STADIUM SCOREBOARD REPLACEMENT AT BUENA HIGH SCHOOL

BID # E8-24

ADDENDUM #02

Bid Addendum 2

AS-1.0

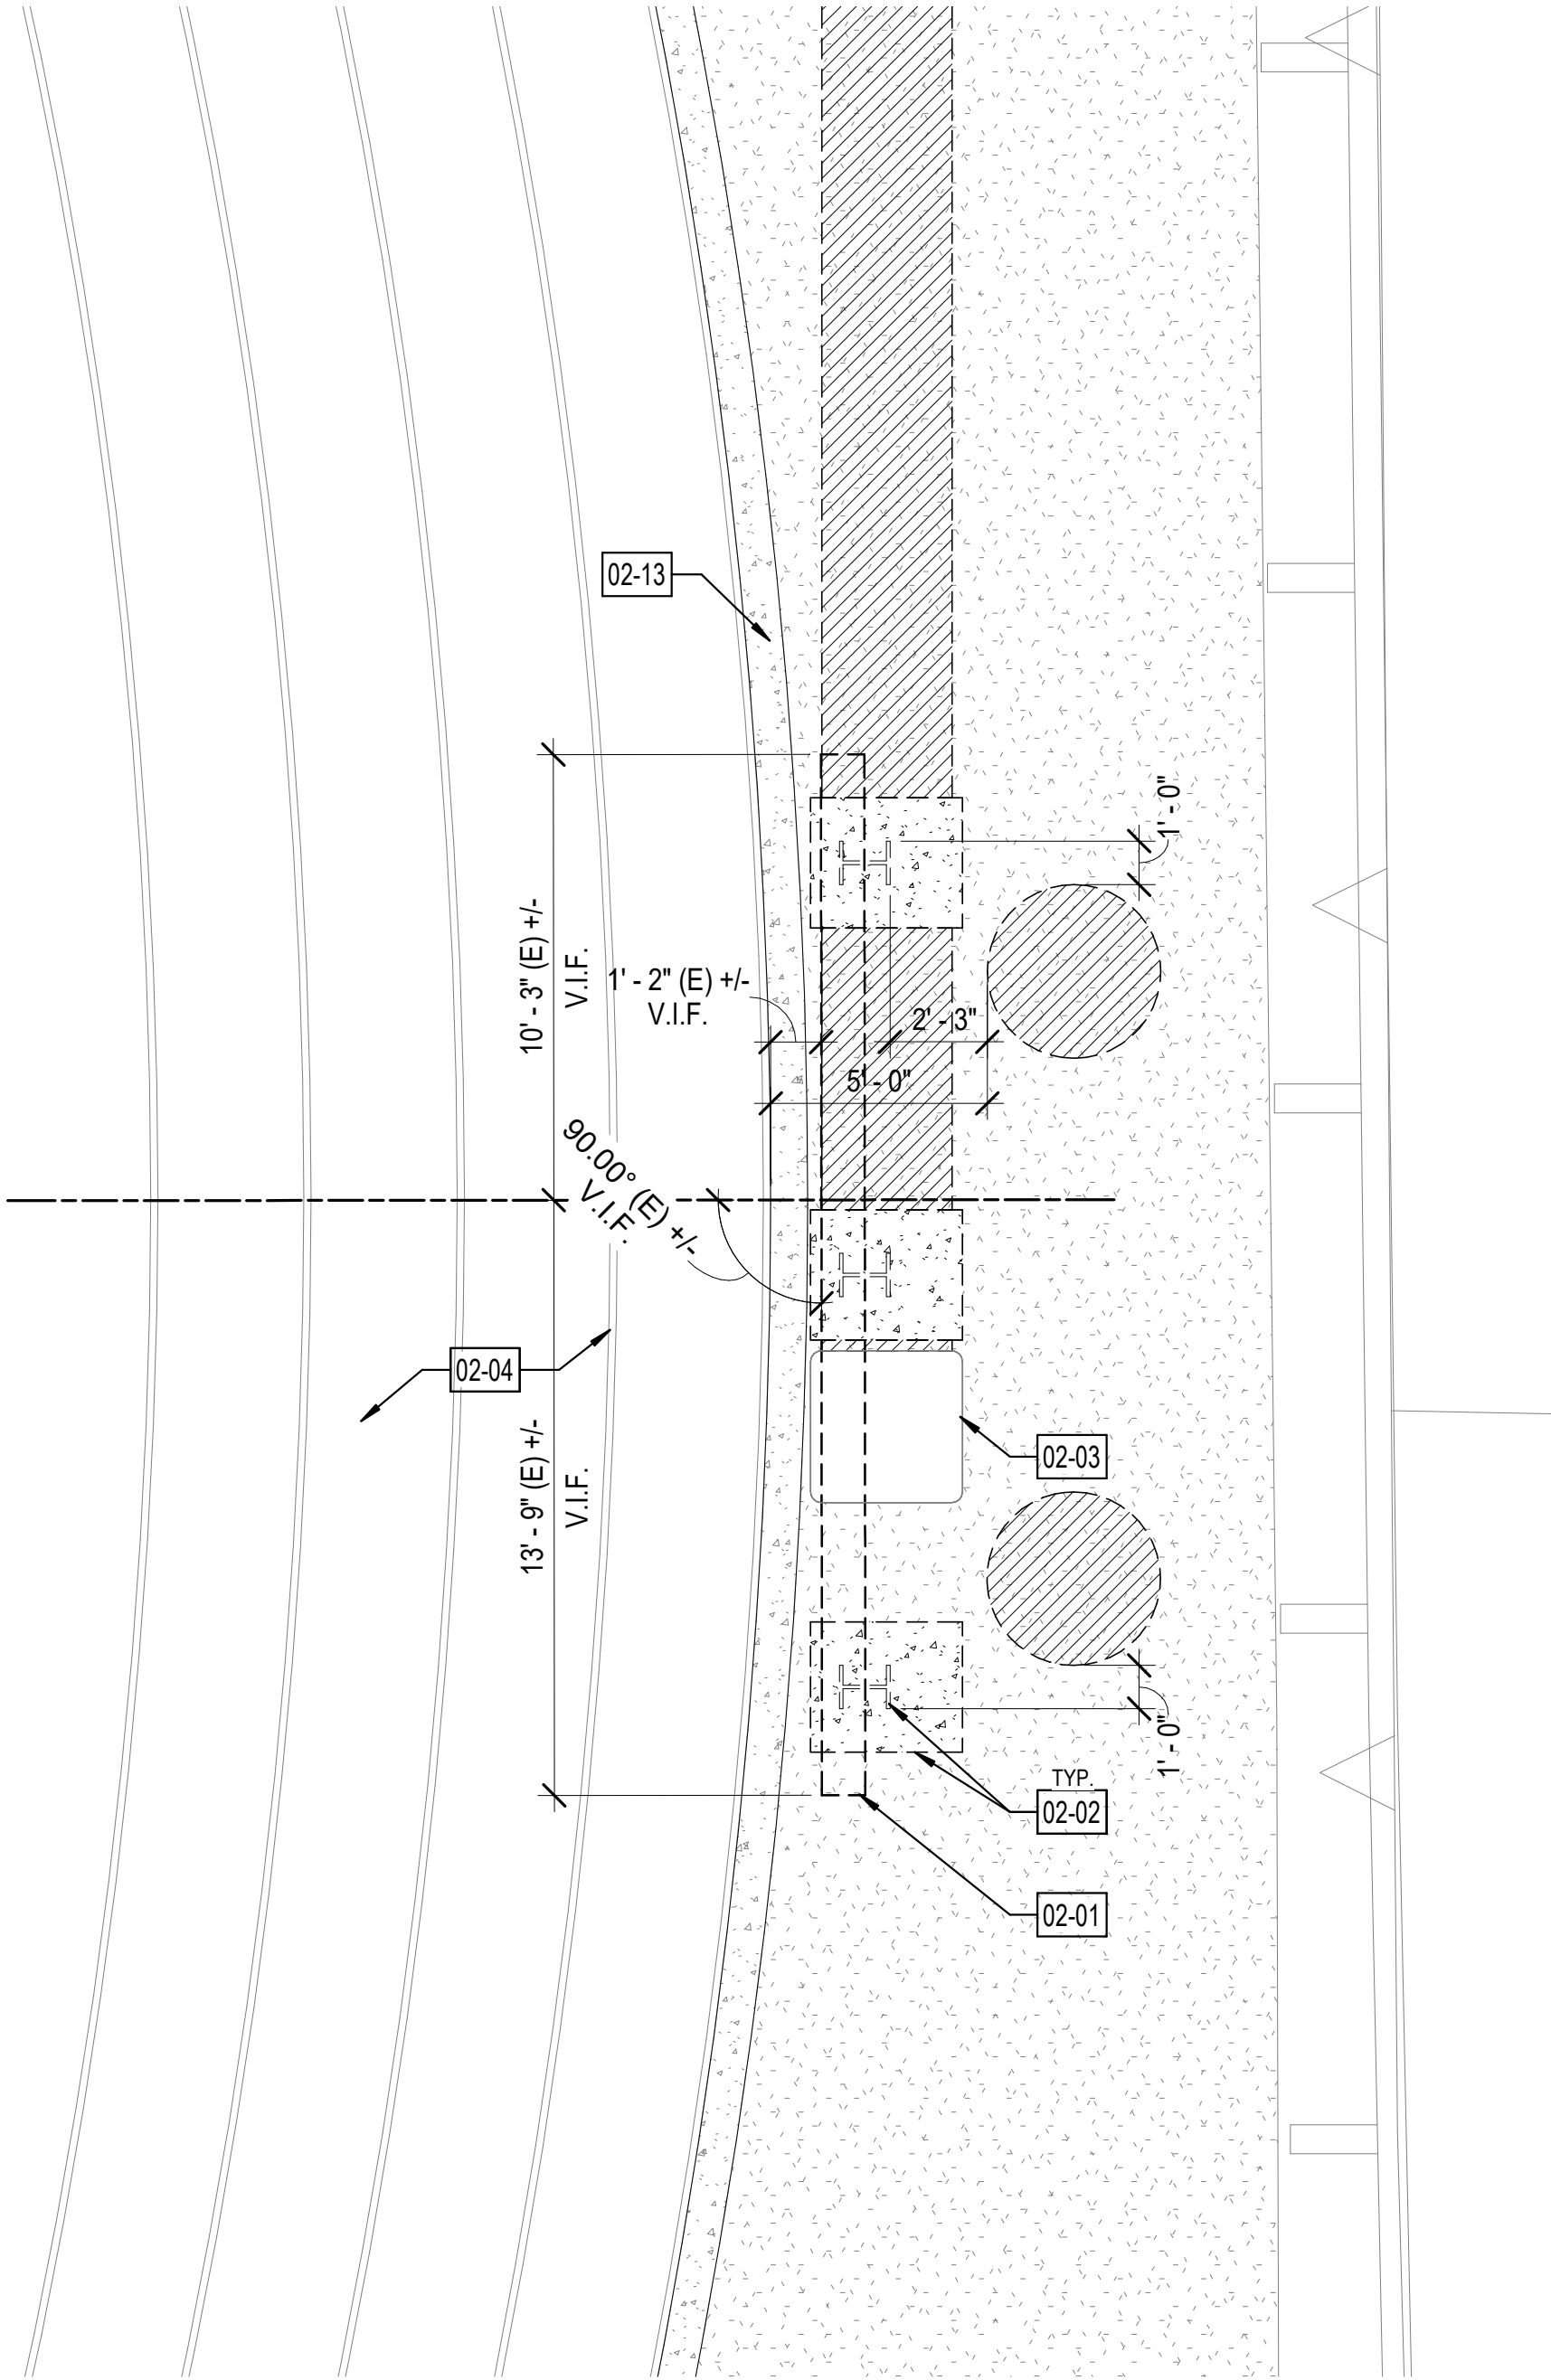
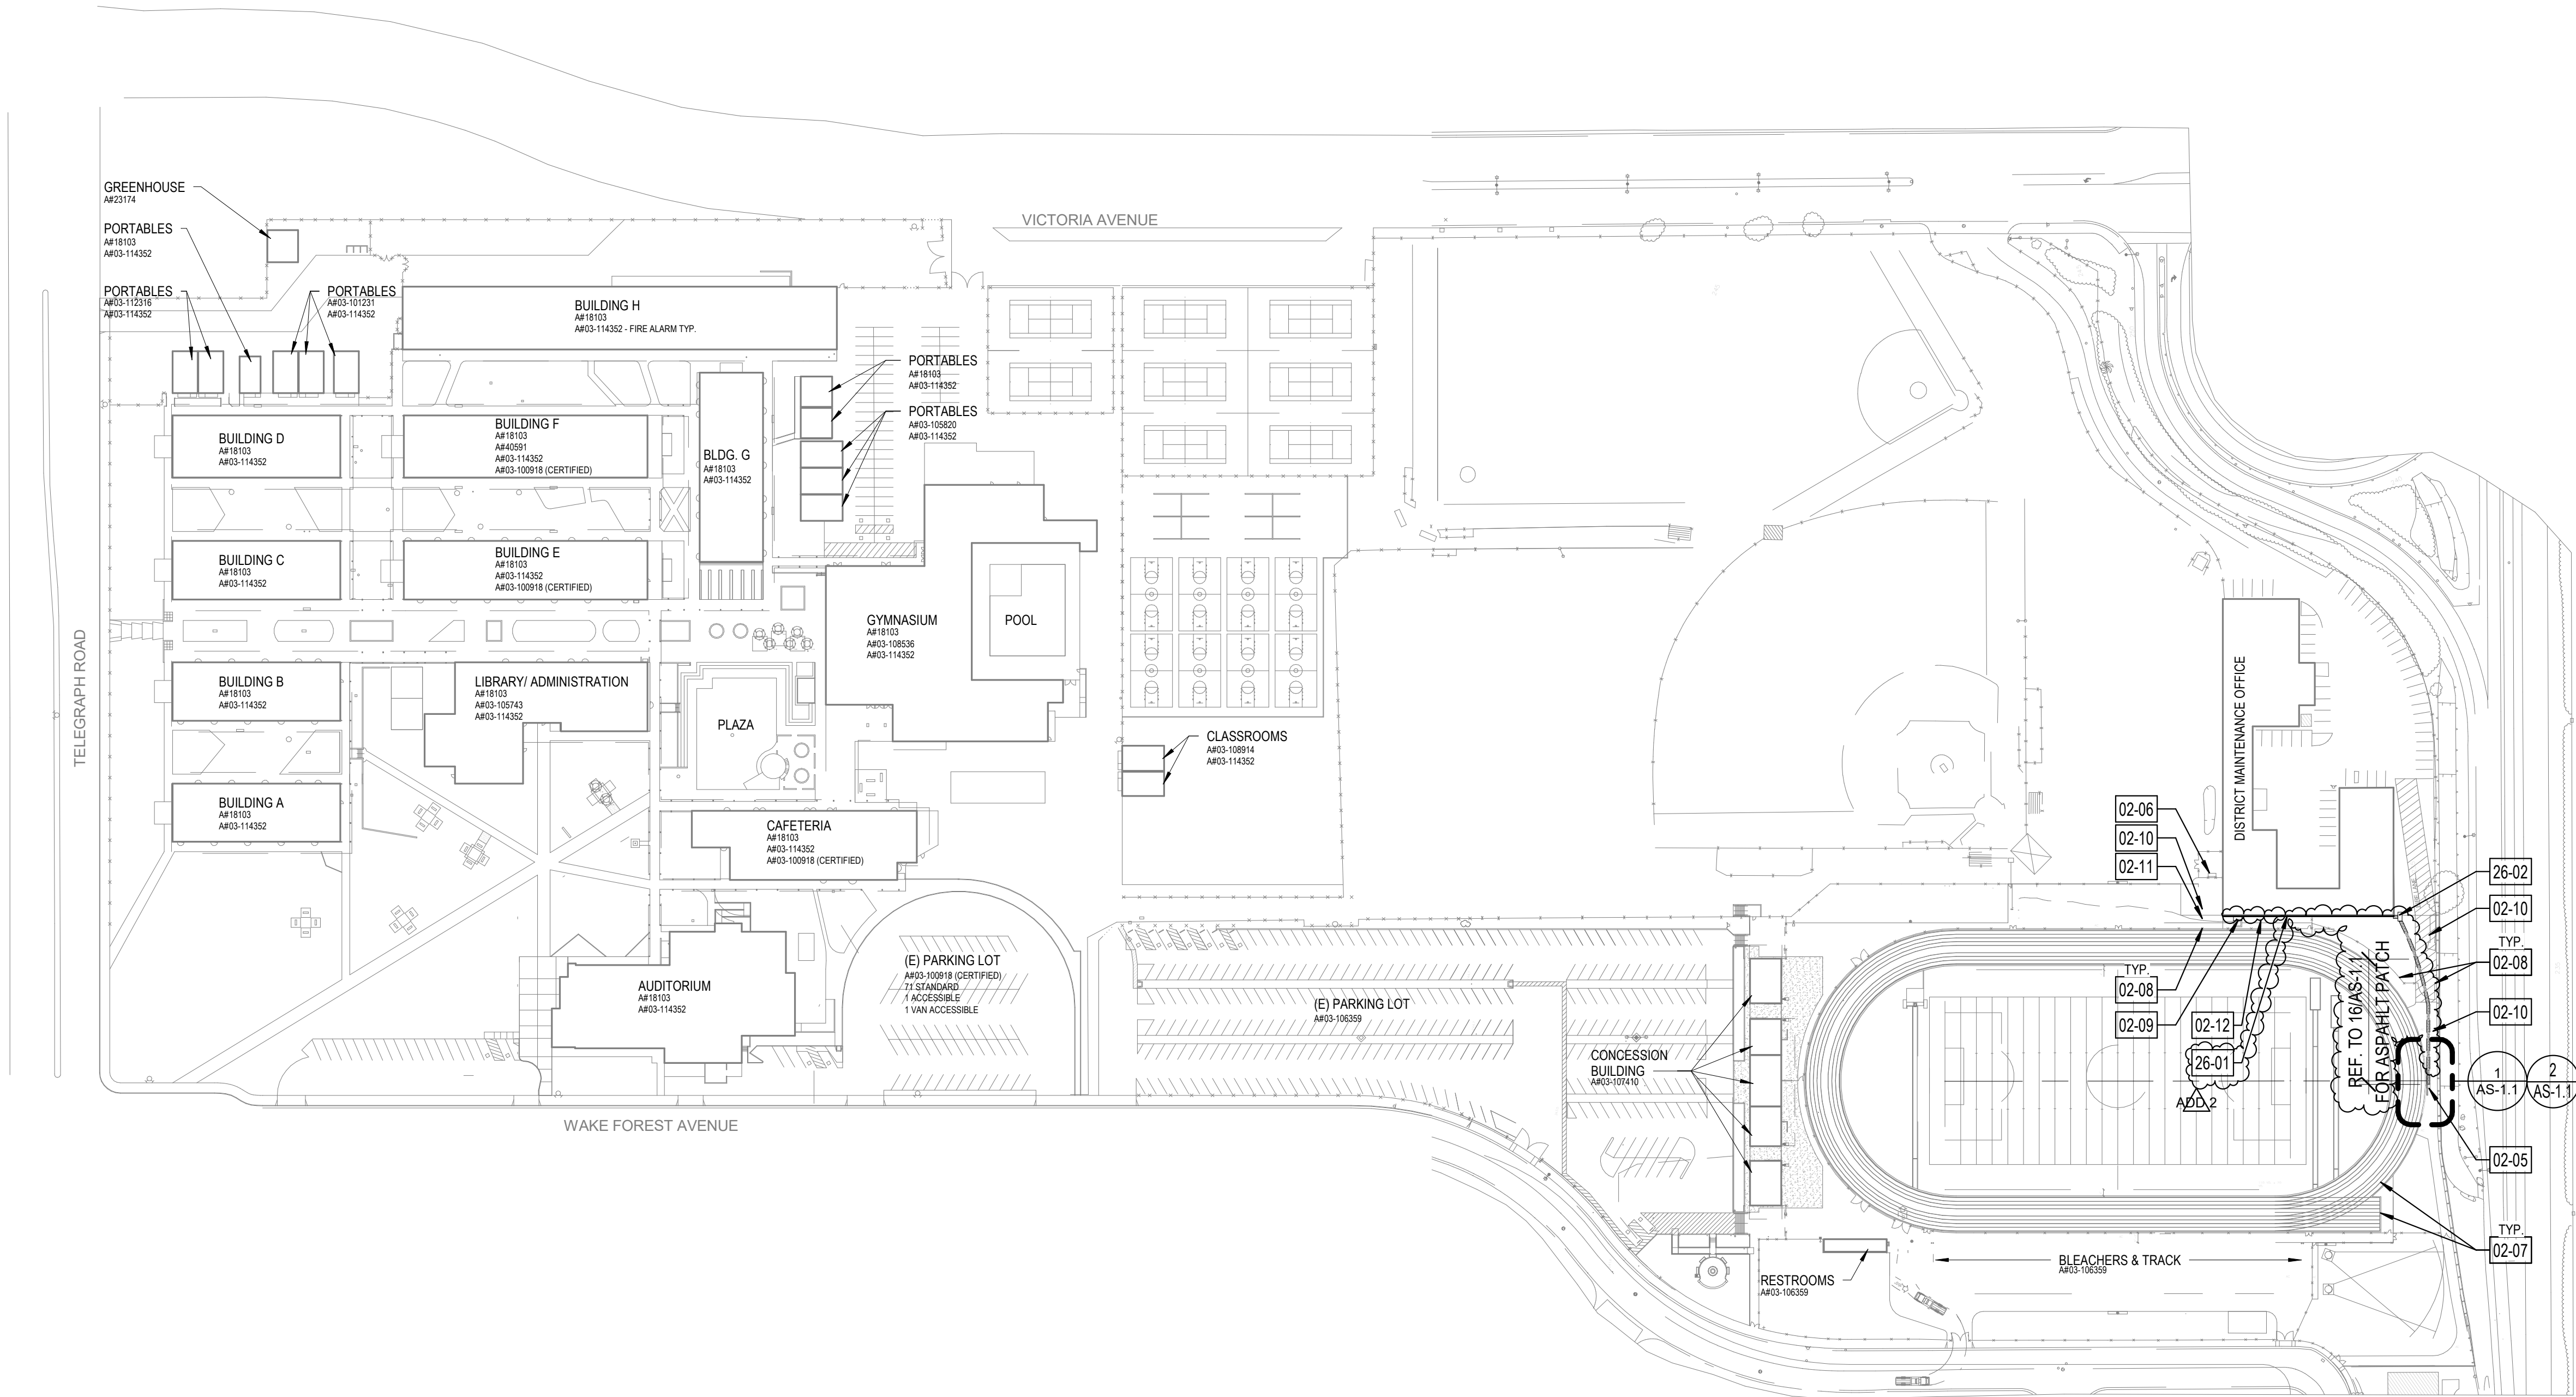
- Item 1.** AS-1.0: Rerouted trench for electrical conduit & added section of wall mounted conduit to existing maintenance building.
- Item 2.** AS-1.0: Added keynote 26-01.
- Item 3.** AS-1.0: Added new pullbox and keynote 26-02.
- Item 4.** AS-1.0: Added dim. note on asphalt area.
- Item 5.** AS-1.0: Updated trenching note on Legend.
- Item 6.** AS-1.1: Added detail 16.
- Item 7.** AS-1.1: Updated keynote 02-01.
